Re: **TRI-COUNTY COUNCIL/CAREER CENTER SITE IMPROVEMENTS PROJECT**
Salisbury, Maryland
2009145.00

ADDENDUM SIX

C-SK1

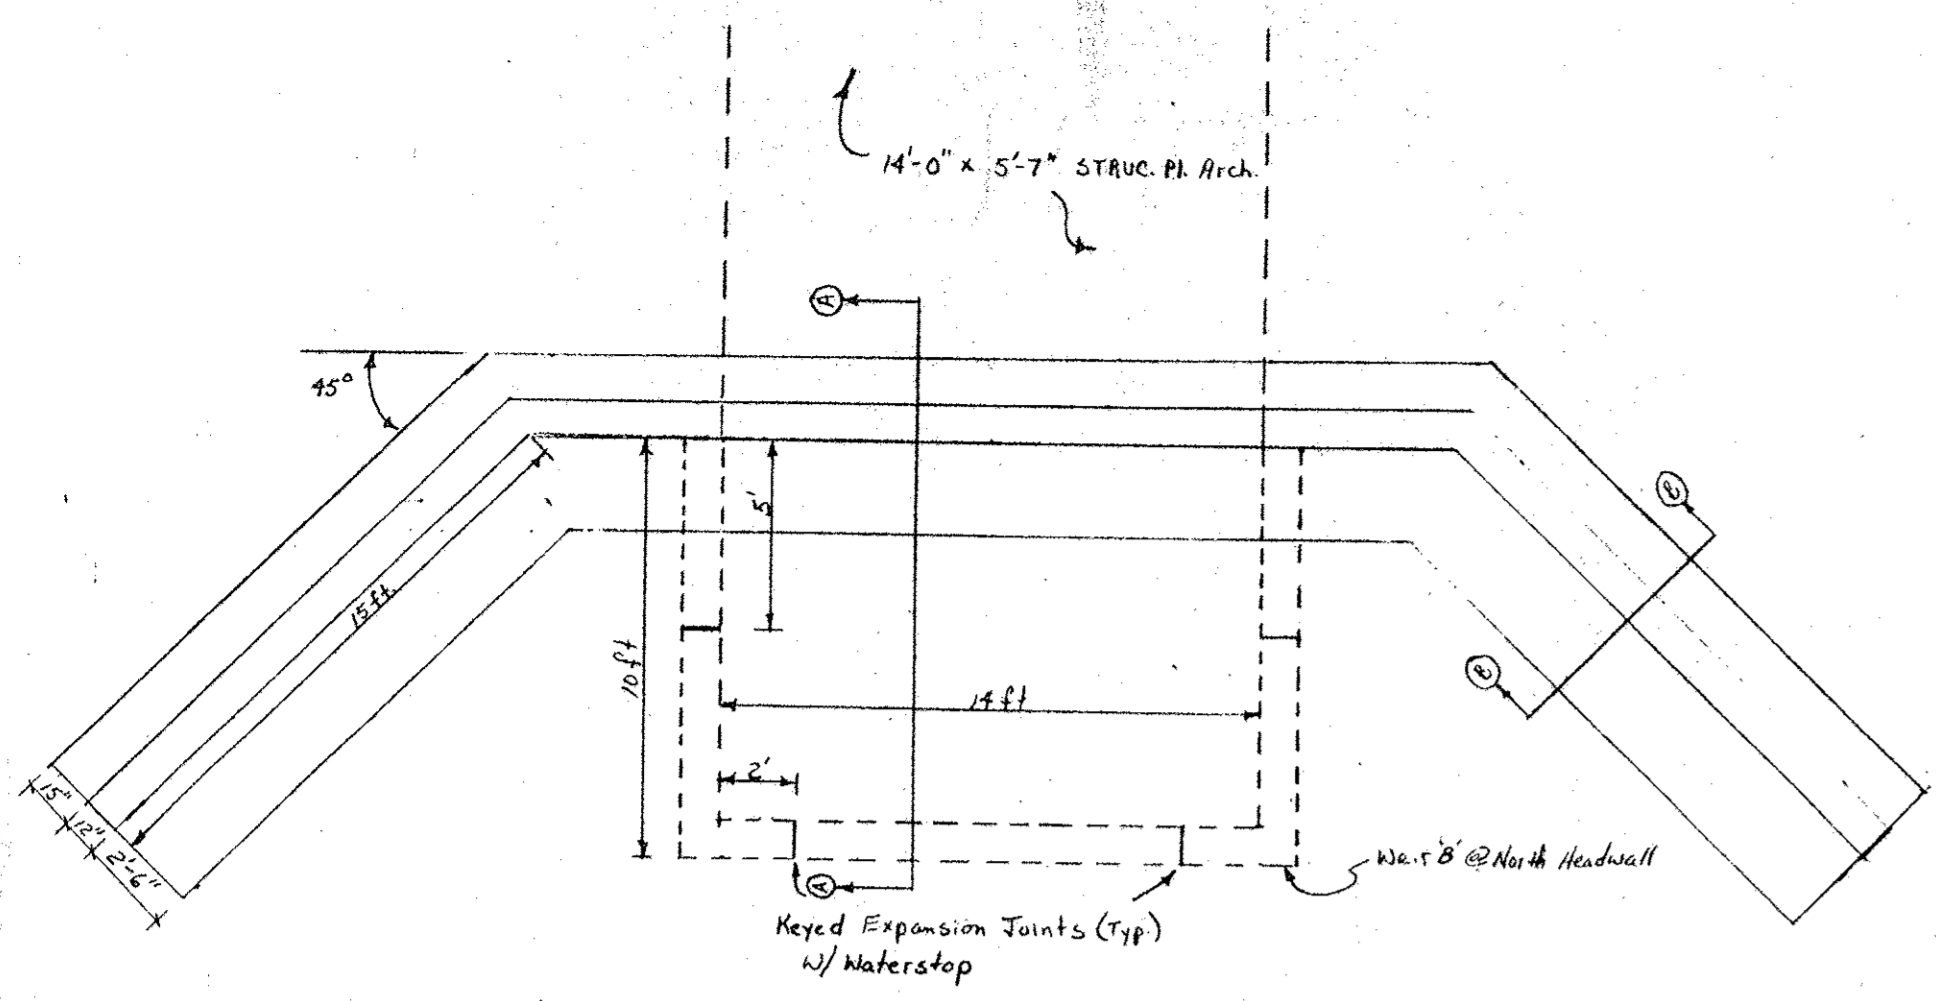
1. Please note receipt of all addendums on Bid Form (Revised).
2. There is a conflict between the Storm Drain Pipe schedule on page C-301 and the Utility profiles on C-305. Which is the governing entity in this situation the Pipe schedule or the Profile?

1. SHEET C-305, UTILITY PROFILES
 - a. REPLACE "PROFILE FROM CATCH BASIN 5 THROUGH CATCH BASIN 1" with BMG Sketch C-SK1 issued via this addendum.

Answer: The schedule is correct. See Sketch C-SK1 issued via this addendum.
3. Is the Contractor required to remove the existing culvert pipe between the 2 headwalls (R-12) designated for removal on plan sheet C-101? Are any details available for the existing culvert pipe and headwalls?
